Report Title	Response to Sussex Surveyor's Report
Project Number	1733
Site Address	Burgess Hill Park Centre RH15 8ET
Date	30/11/2022
Author	Brendan Haworth
Checked	Des McCall IStructE MICE
Status	Final
Revision

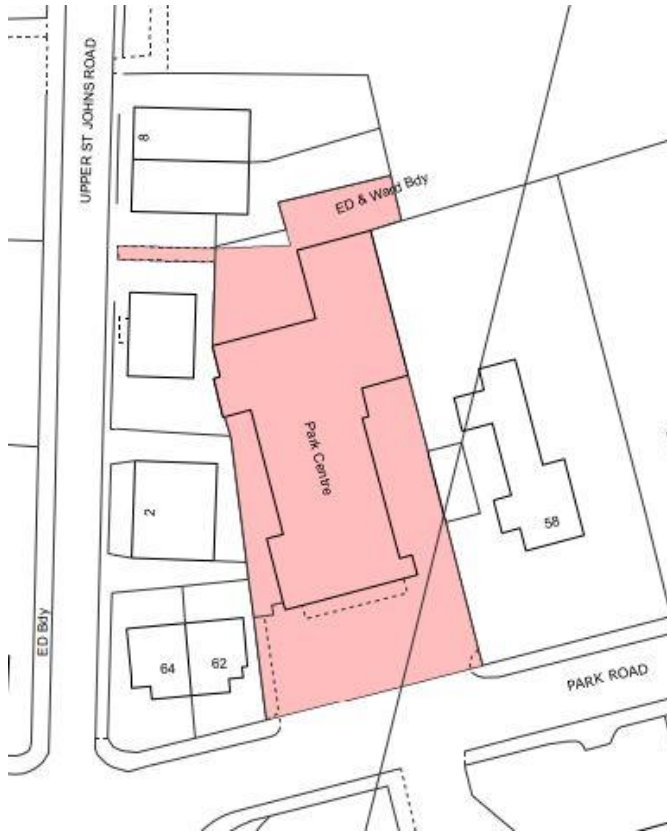
The site plan opposite confirms that the building is orientated so that the front elevation is facing nominally south. A photograph of the front elevation is at the report cover-page.
